# Wisconsin Department of Transportation

**Proposal #10: 6190-15-72, WIS 2017 281**  
**Main St, Village of Winneconne**  
**Wolf River Bridge & Approaches**  
**STH 116**  
**Winnebago County**

This is Addendum No. 01, which provides for the following:

**ADDENDUM NO. 01**  
**6190-15-72 & 6190-15-74**  
**July 25, 2017**

Addendum No. 01  
ID 6190-15-72  
Added Sheet 15A  
July 25, 2017

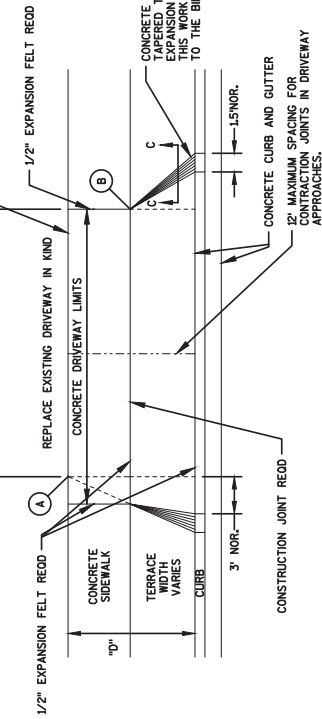
<b>Added Plan Sheets</b>	
Plan Sheet	Plan Sheet Title (brief description of why sheet was added)
15A	Added driveway detail

Addendum No. 01  
ID 6190-15-72  
Revised Sheet 20  
July 25, 2017

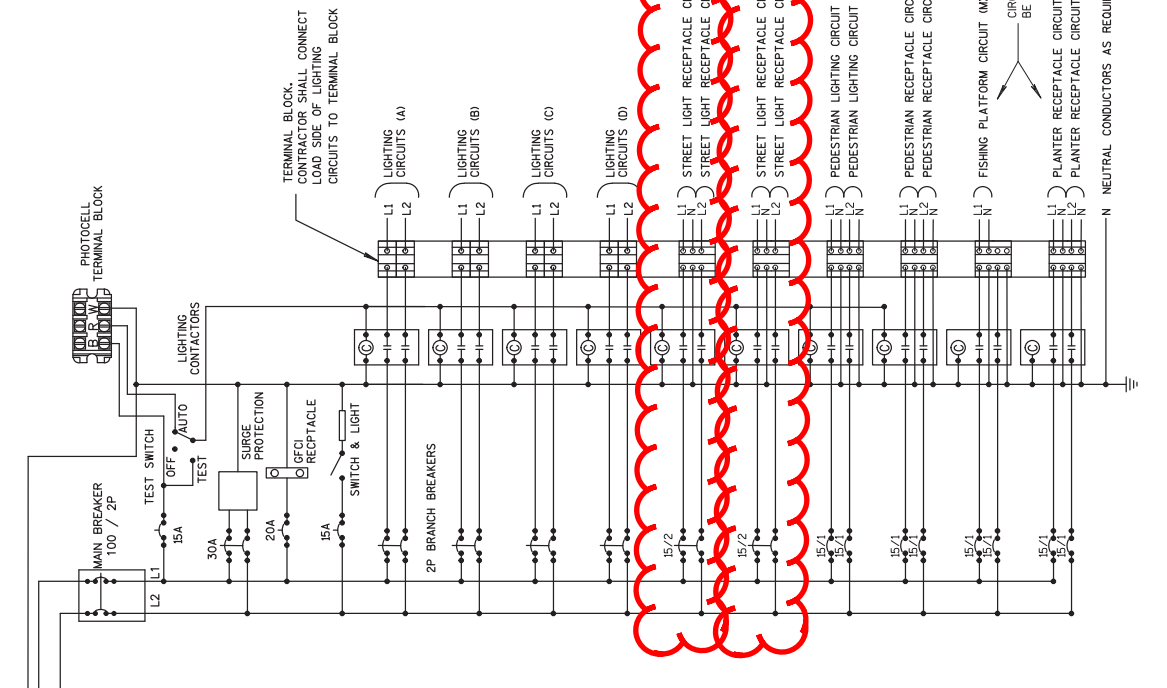
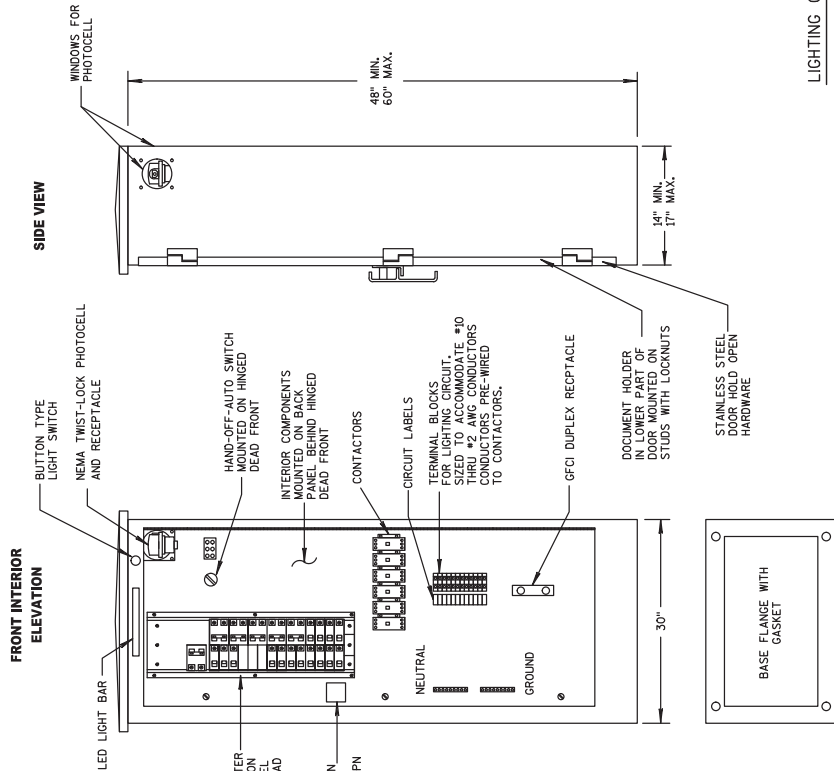
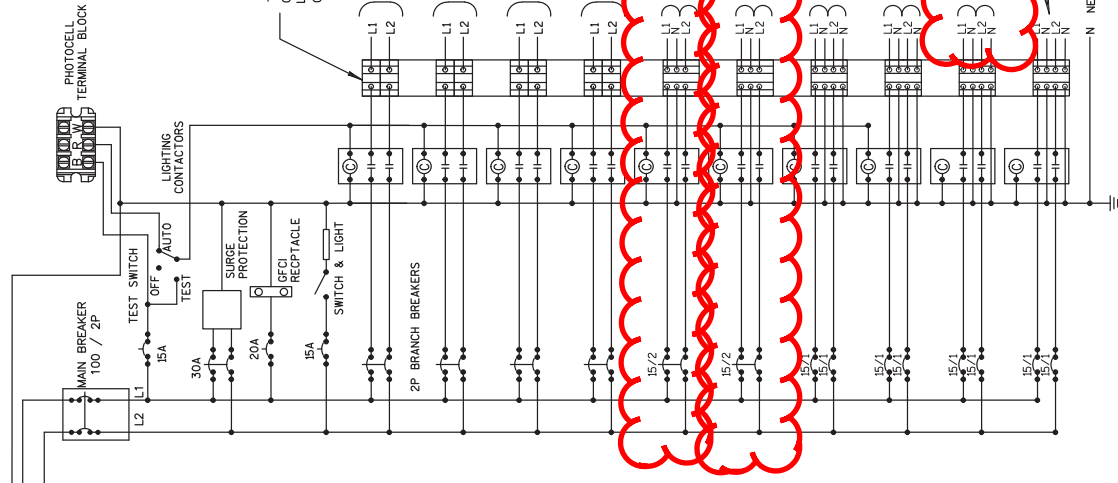
Revised Plan Sheets	
Plan Sheet	Plan Sheet Title (brief description of changes to sheet)
20	Lighting receptacle conductors placed on shared trip breakers
21	Lighting receptacle conductors placed on shared trip breakers; added radar board circuit
66	Lighting receptacle conductors placed on shared trip breakers; added radar board circuit
72	Revised for shared trip breakers and radar board conductors
116	Changed quantity of bid item 460.4110.S
125	Changed quantity of bid item 655.0615
126	Changed quantity of bid item 655.0615

Addendum No. 01  
ID 6190-15-72  
Revised Sheet 326  
July 25, 2017

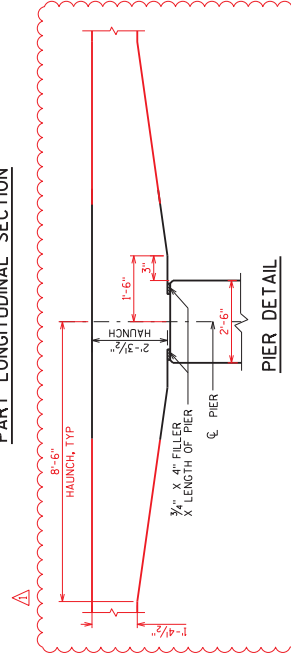
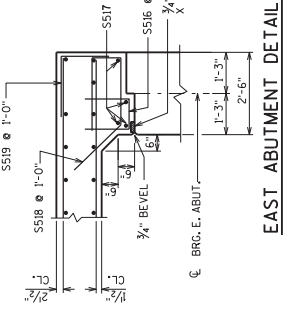
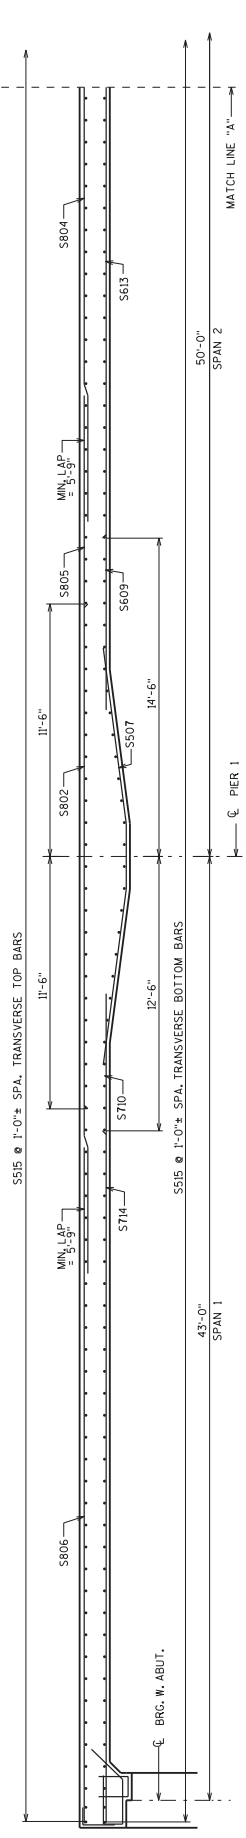
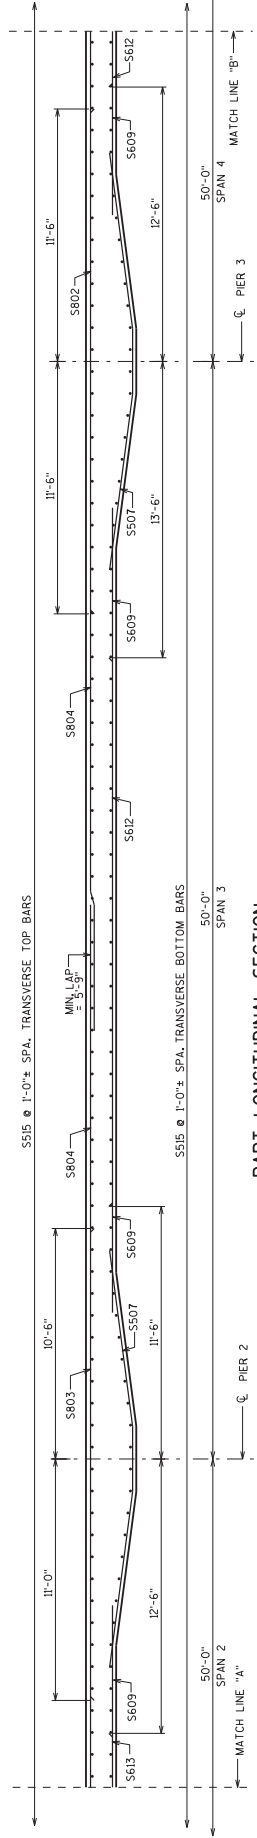
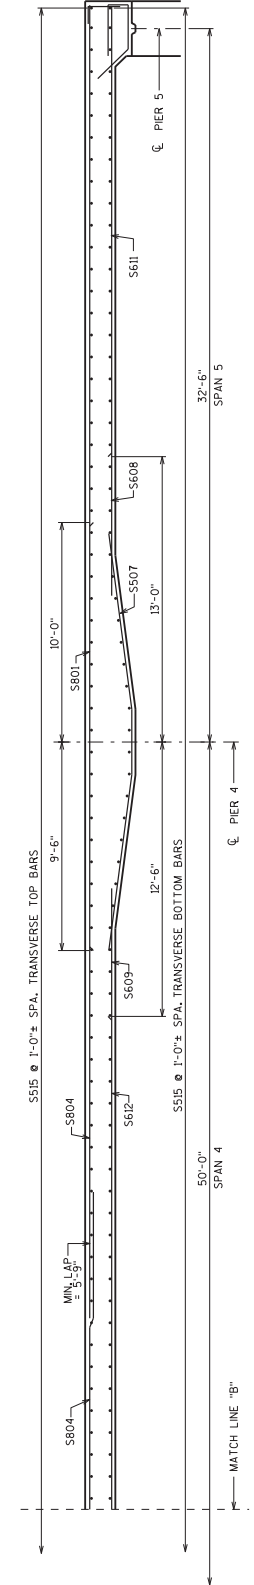
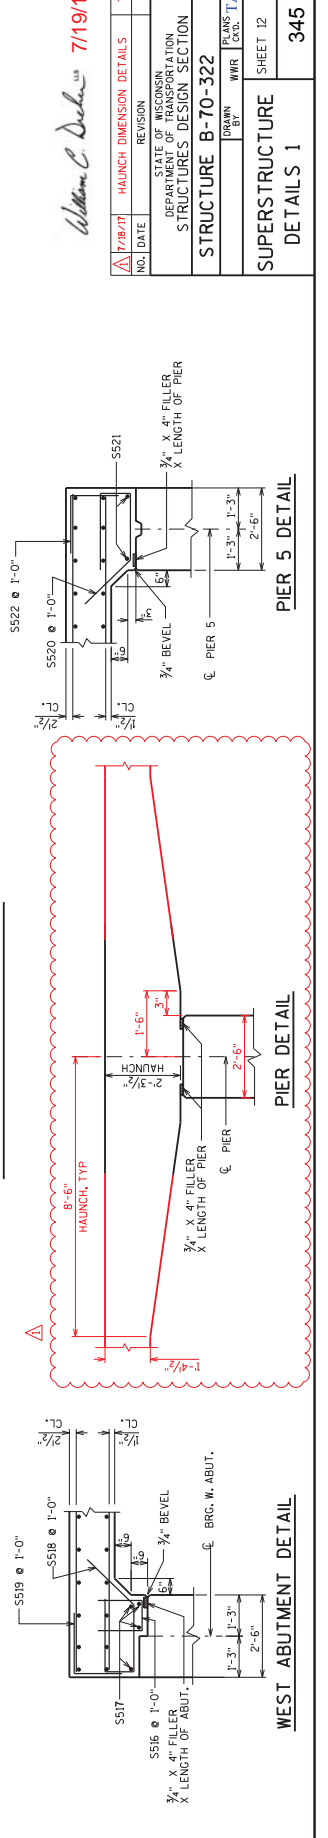
326	Added haunch dimension for B-70-321
345	Added haunch dimension for B-70-322

7/8" x 4" FILLER X LENGTH OF PIER	HAUNCH DIMENSION	DETAILS	TAB	BY
DATE	REVISION			
STATE OF WISCONSIN DEPARTMENT OF TRANSPORTATION STRUCTURES DESIGN SECTION				
STRUCTURE B-70-321				
DESIGN BY	DRAWN BY	CHKD.	TAB	BY
SUPERSTRUCTURE SHEET 12				
DETAILS 1 326
